**MEMORANDUM**

**Subject:** Comprehensive Plan Update, Neighborhood Plan Updates – NE 85<sup>th</sup> Street Subarea Plan Revisions File No. CAM13-00465, #5 and #14c

# NE 85<sup>TH</sup> STREET SUBAREA PLAN

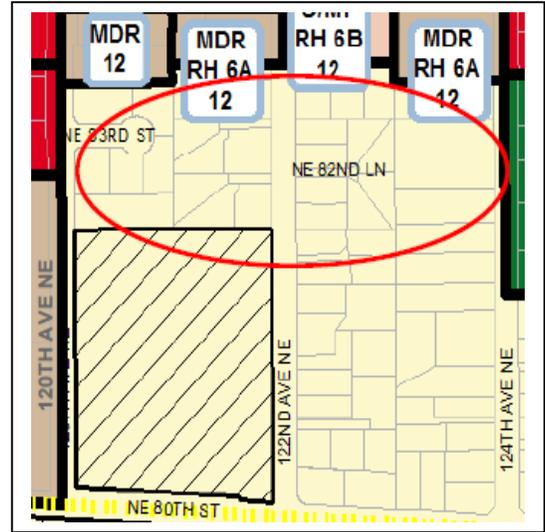
1. A few residents in the South Rose Hill Neighborhood submitted two new text changes to the South Rose Hill Neighborhood Plan that would affect the NE 85<sup>th</sup> Street Subarea Plan. The changes would result in a change in land use (rezone) from low density residential currently zoned RS 7.2 to medium density nine dwelling units per acre (RM 5.0 zoning) and/or change an existing RM 3.6 area from 12 dwelling units per acre to office/mixed use at 24 dwelling units per acre or RM 1.8. (see Attachment 2 neighborhood review comments on pages 9 and 11).

No maps were submitted but the requests seem to refer to the area shown below south of the RH 6A and 6B medium density/office zones located between 120th Avenue NE and 124<sup>th</sup> Avenue, north of the cemetery (see figure below).

*Staff comment: Based on the public process set up for the Citizen Amendment Requests and scope of changes for the Neighborhood Plan update process, staff believes this request would be a land use policy change that ideally should have been submitted as a Citizen Amendment Request.. However, the proposal could be considered if the Planning Commission feels it has merit. It would not be a CAR, rather a plan change initiated by the neighborhood or Planning Commission. Staff is concerned that the request is not supported by the neighborhood association. The Planning Commission should discuss these two text change requests and provide direction to staff.*

Figure NE85-21: NE 85th Subarea Land Use

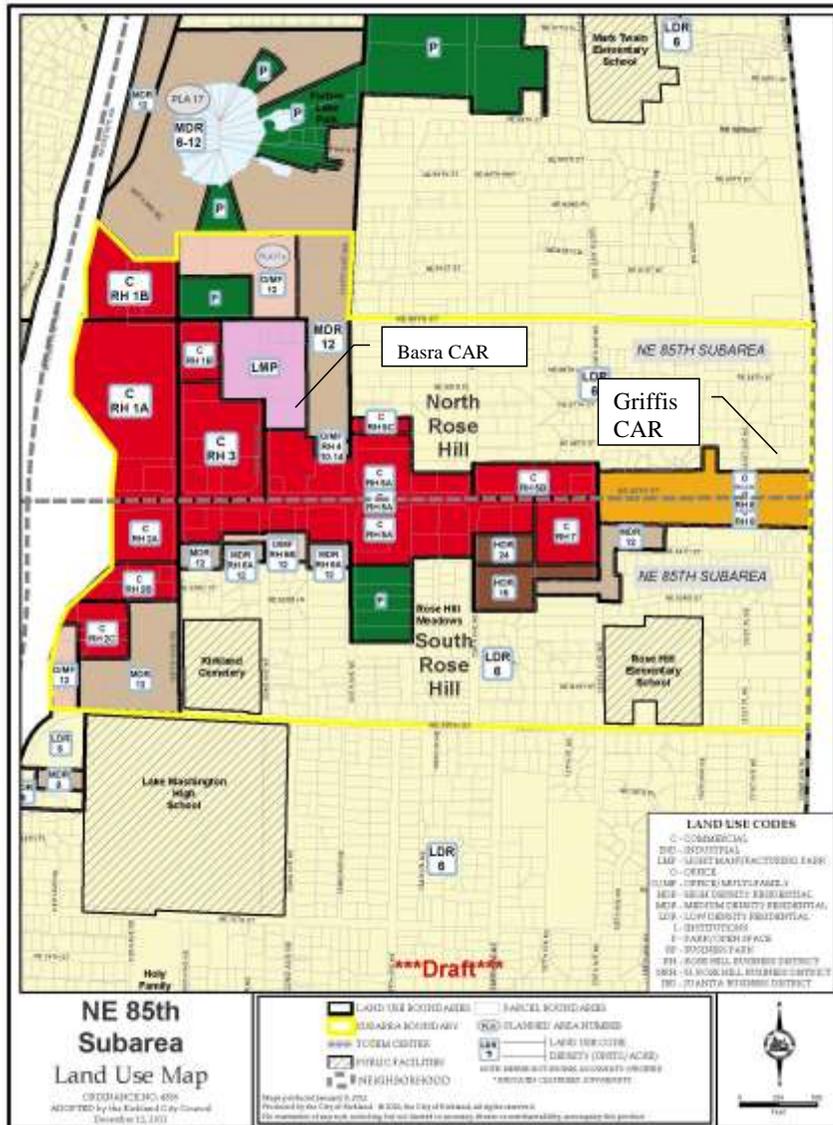
**Commented [JC5]:** Depending on the outcome of the Basra and Griffis Citizen Amendment Requests being considered with the update of the North Rosehill Plan the land use map and text may need changing.

**Figure NE85-53: NE 85th Subarea Landslide and Seismic Hazards**

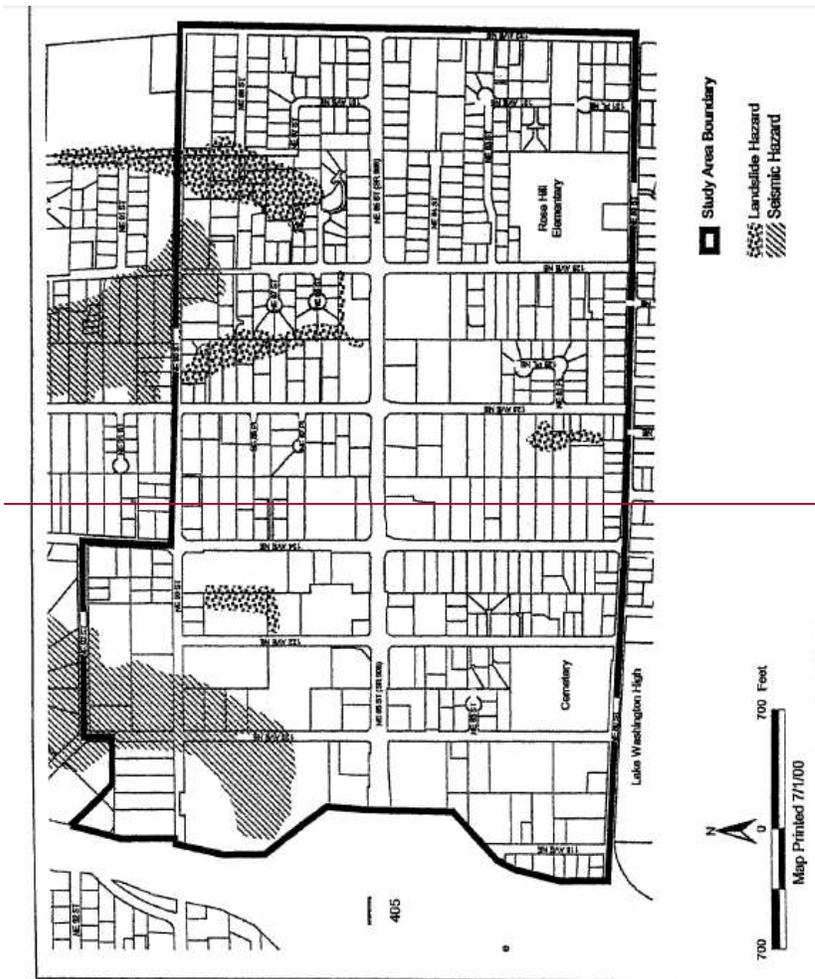
**Commented [JC22]:** Not needed because figures are located in North and South Rose Hill neighborhoods.

Figure SRH-1: South Rose Hill Regional Influences

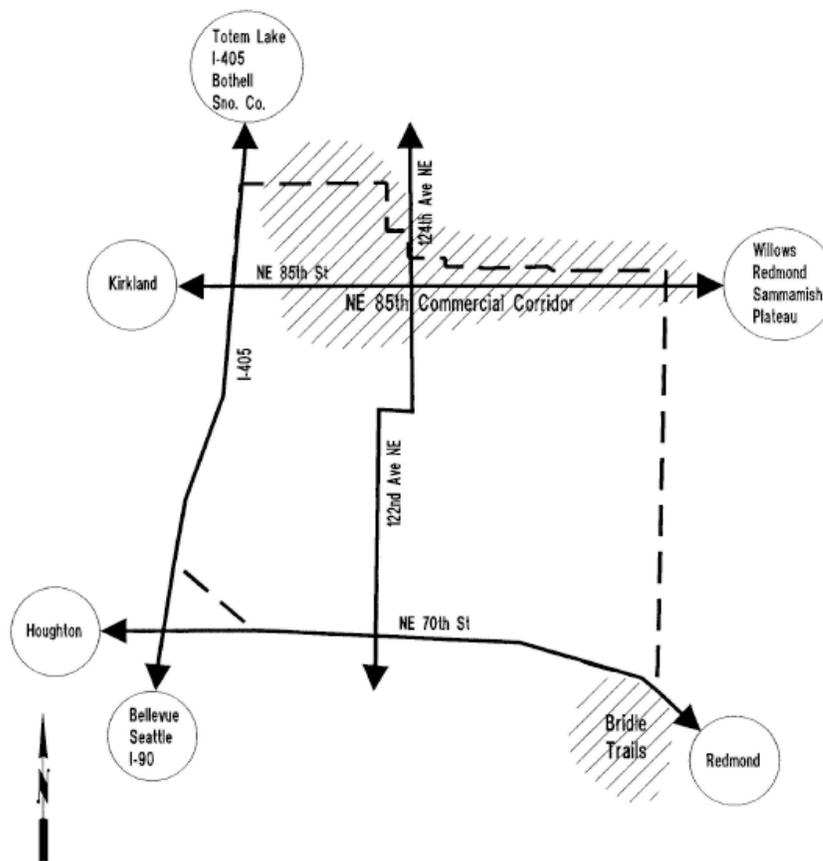
Note: Delete Figure 1; not needed.

Figure SRH-8: South Rose Hill Urban Design Elements

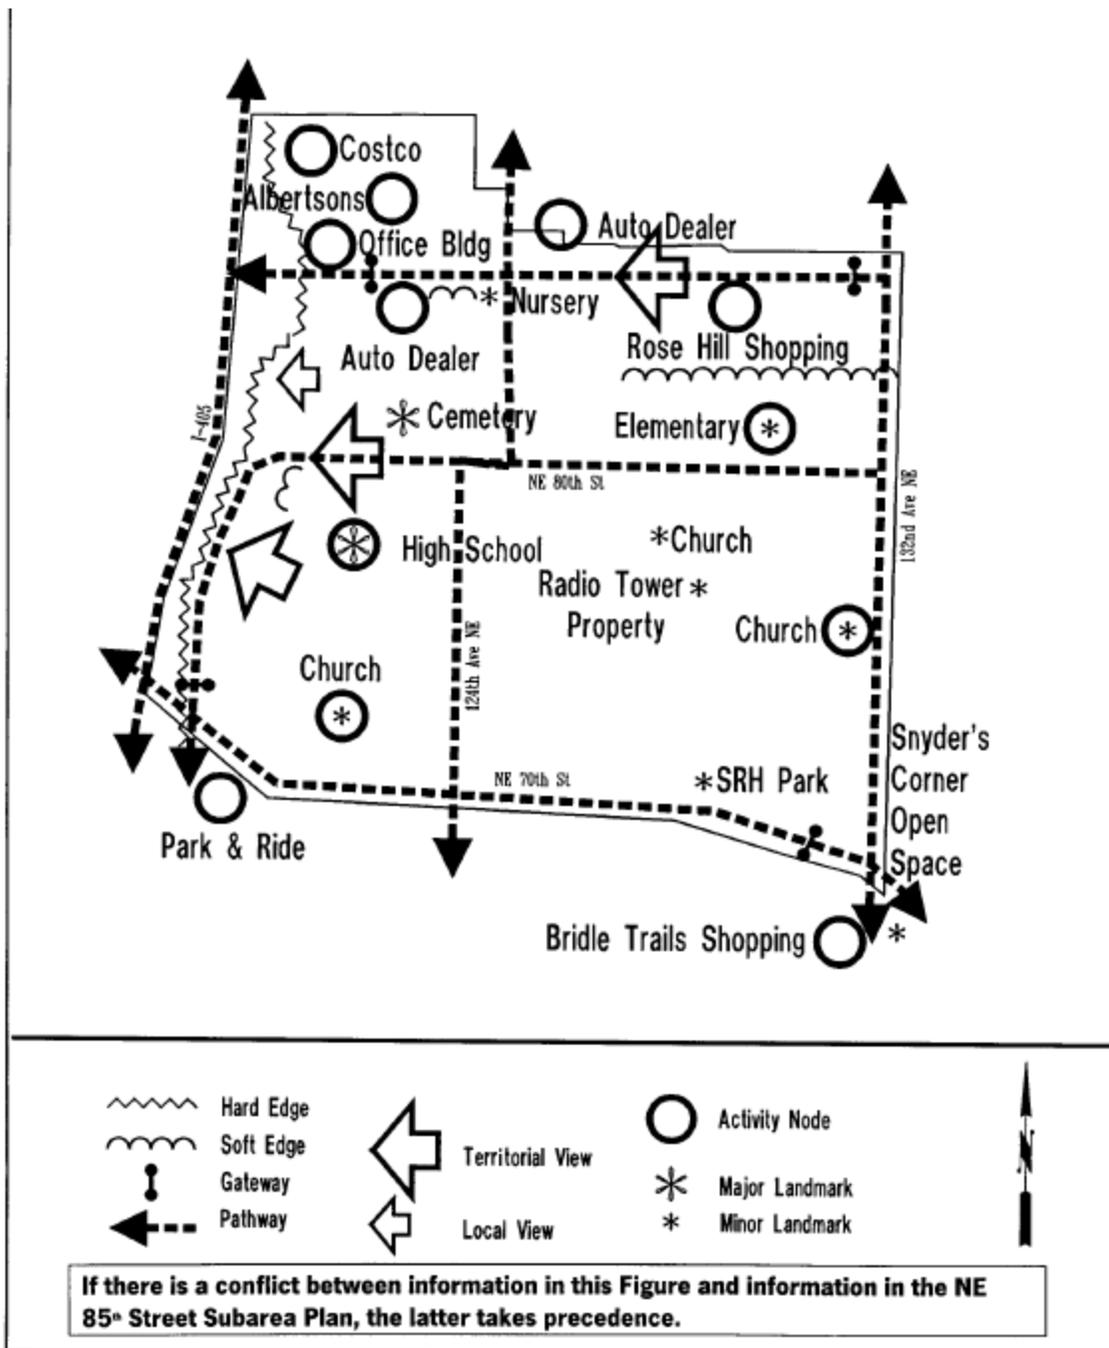
Note: Update Figure below to delete Albertsons, Nursery, Radio Tower property, add Rose Hill Meadows, and neighborhood commercial
